INITIAL FIRE SAFETY INSPECTION REPORT

Panmark Apparels (Pvt) Ltd.

RSC ID: 26544

Fire Safety Inspection Report

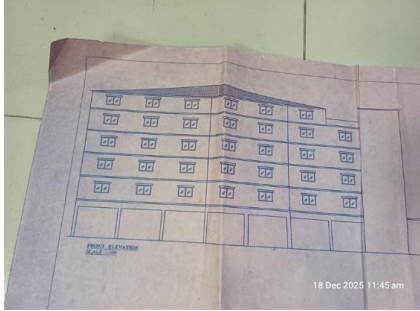
F-02	Means of Egress	Unsealed penetrations and openings are located in exit stair enclosures. Location(s): Electrical cable passing through the exit stair enclosure-2 on 2nd and 3rd Floors in Main Production Building.	No other penetration into and through the exit enclosure except for fire alarm equipment electrical raceway, required exit doors, sprinkler piping, standpipes, and electrical conduit serving the exit enclosure is permitted in accordance with section 6.14.4 of RSC Technical Guidelines (Standard)¹ V1.0. So, relocate the electrical wires/raceways to somewhere else avoiding the exit enclosure, and seal the created unprotected openings with a minimum of 1.5 hours listed/certified fire-rated materials. Installation shall be as per manufacturer published installation guideline and the certification authority guideline to ensure the fire-rating. Or, Seal the penetration by 2-hr masonry construction.	Within 3 Months
